# Staff Report

## Infill Housing Design Review Committee

File Number: 10-E-21-IH

**Location:** 3311 Savoy St. **Parcel ID** 81 P A 011  
**Zoning:** RN-2 (Single-Family Residential Neighborhood)  
**District:** Lonsdale Infill Housing Overlay District

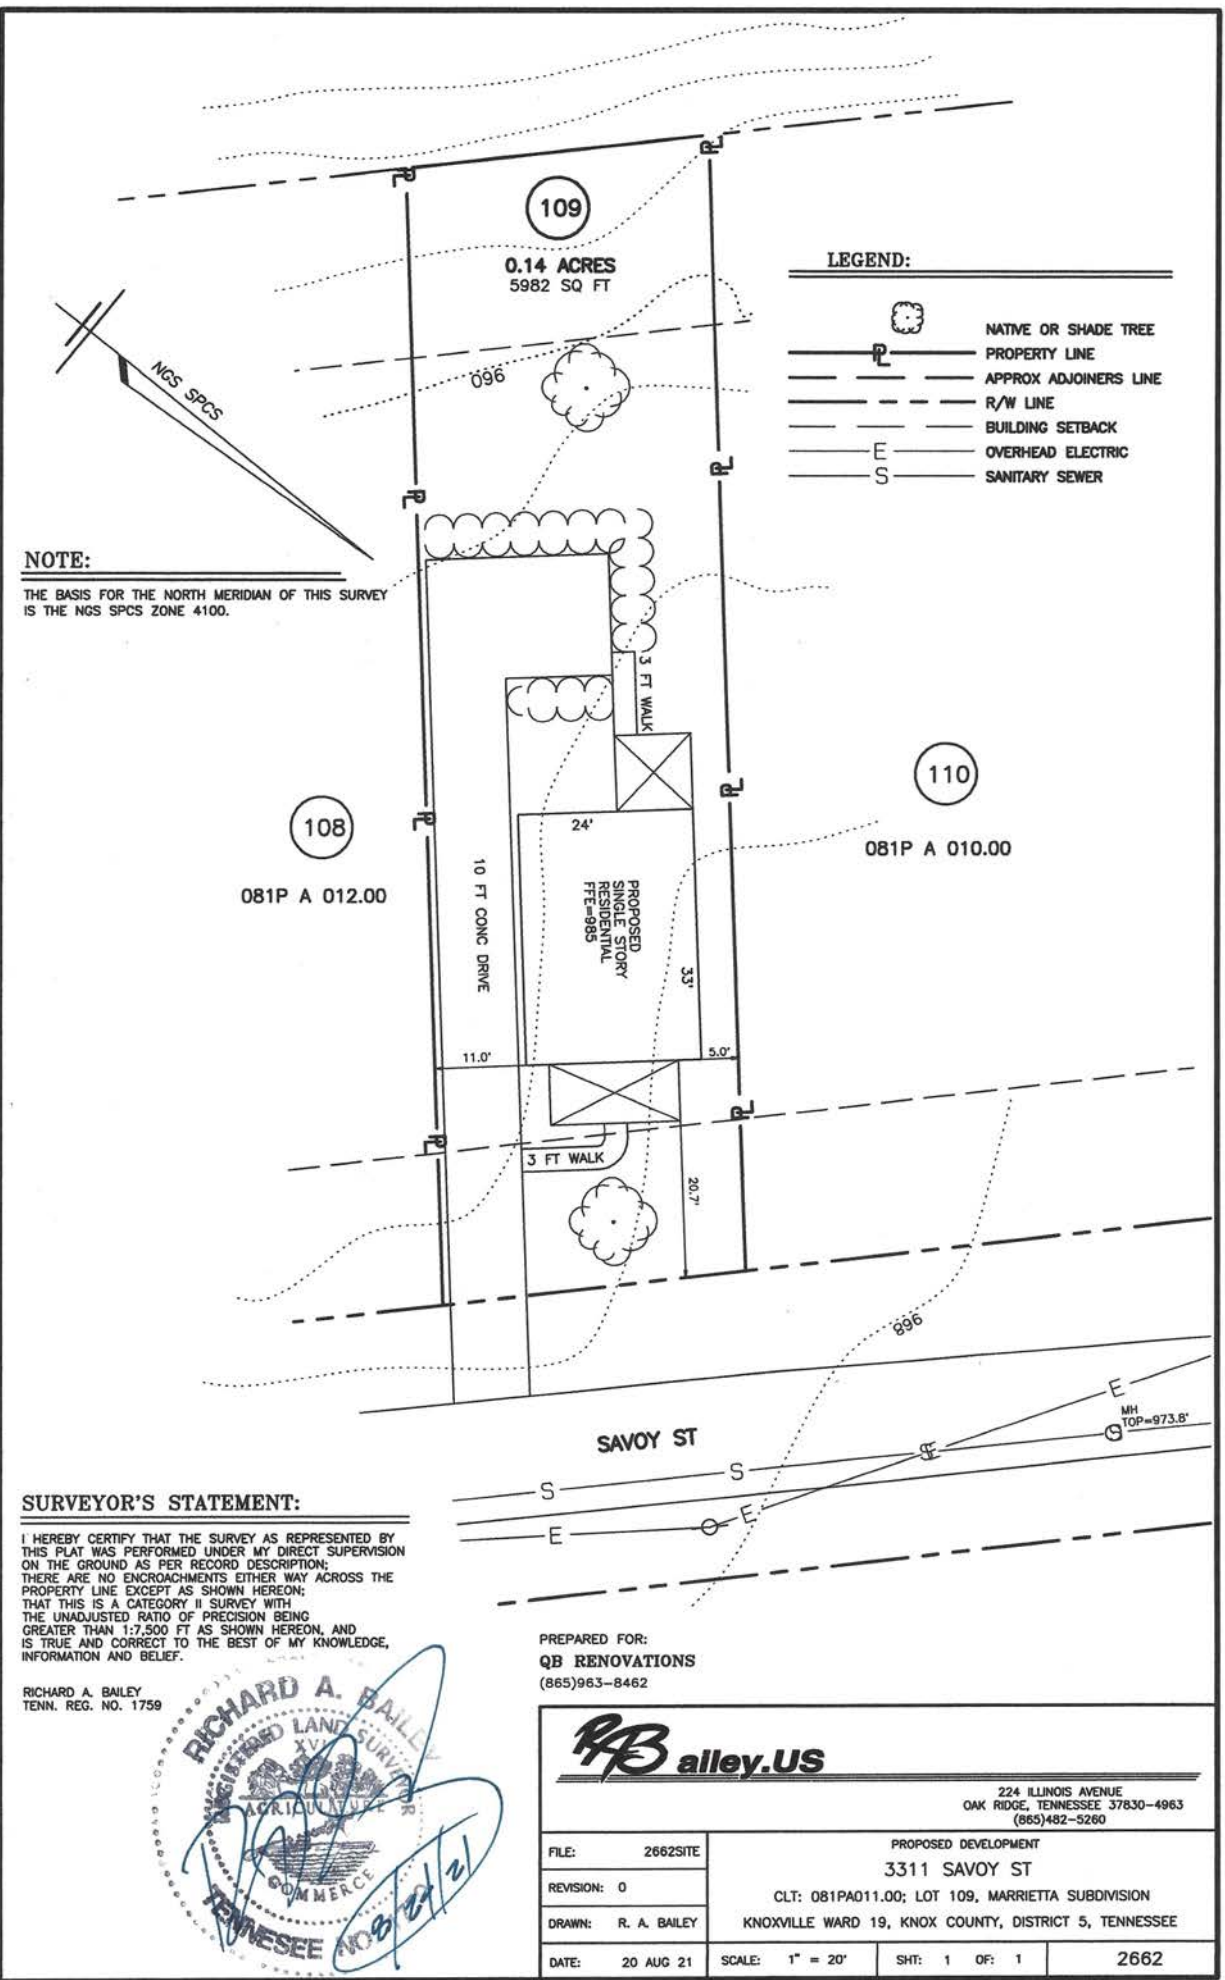
1. The house is proposed to be set 26.7' from the front property line, with a 6' deep front porch located 20.7' from the front property line. The block lacks context to derive an average front setback, as there is only one other house

on the block fronting Savoy Street. The proposed front setback will establish a pattern for the block. Instead of a walkway extending to the street, the applicant has connected the walkway to the concrete driveway.

3. The proposed parking meets Infill Housing design guidelines for a street without an operable alley (limited to one lane and extending at least 20' behind the house's front façade) and City Engineering standards. The applicant has incorporated landscaping to surround the parking pad. The application is right at the impervious surface limit for the base zoning. Any modifications to the site plan during permitting should meet City Engineering standards and remain within impervious surface limits.

5. The proposed front-gable roof porch is proportionate to the façade. A revised porch design should incorporate 6 by 6 or 8 by 8 square supports. A covered rear elevation porch is shown on the site plan but not the elevation drawings; drawings should be updated accordingly.

9. The site plan includes new front and rear yard trees.

- 1) Final site plan to meet City Engineering standards;
- 2) Incorporate raised foundation (1' or taller) instead of concrete slab;
- 3) Use one-over-one windows with appropriately-sized trim;
- 4) Add one or two windows to the left elevation, with approval by staff;
- 5) Use lap siding with an overlap instead of Dutch lap or flush panel siding.
